Infinity Fryers/ Falcon 350 Gas Fryers
Dominador Gas and Electric Fryers
Chieftain Gas and Electric Fryers

Replacement Safety Thermostat Fitting Instruction

T100535 Ref. 1

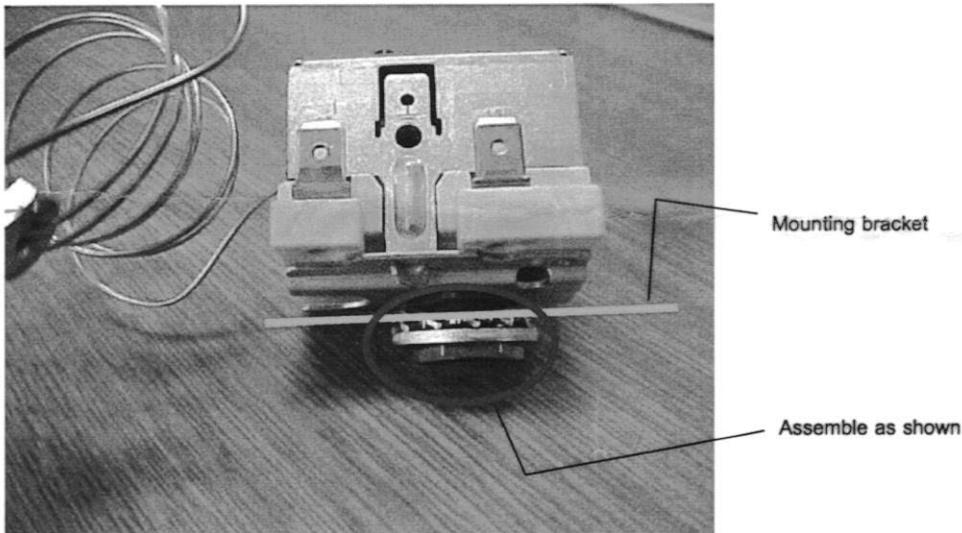
The safety stat body design has been amended and it is now secured in position by means of a nut instead of two screws.

In the event that replacement of the old type is required, fit as detailed using the existing large hole that the re-set button protruded through to accommodate the mounting turret.

As the re-set button is now located within the mounting turret, please ensure that the re-set label enclosed is already applied to unit. If not, position enclosed label over the existing label.
